service bulletin

92-3

Power Steering Actuator Repair Kit – P/N 811632

51246

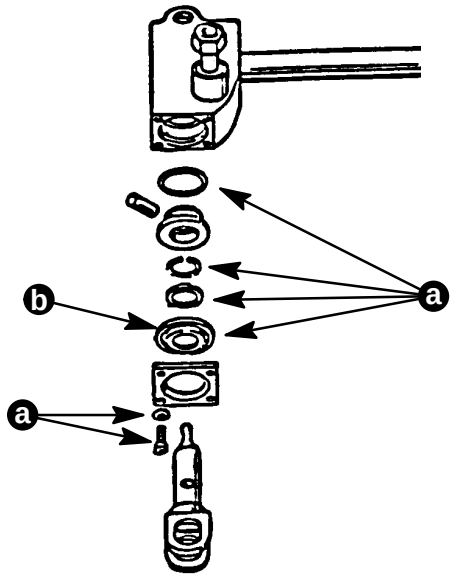
New actuator seal parts are available in actuator repair kit p/n 811632. This repair kit includes O-rings, seals and screws necessary to reseal the actuator.

Apply Loctite 271 (type A) to the threads of the new screws and torque to 25 Lb. In. (2.8 N.m).
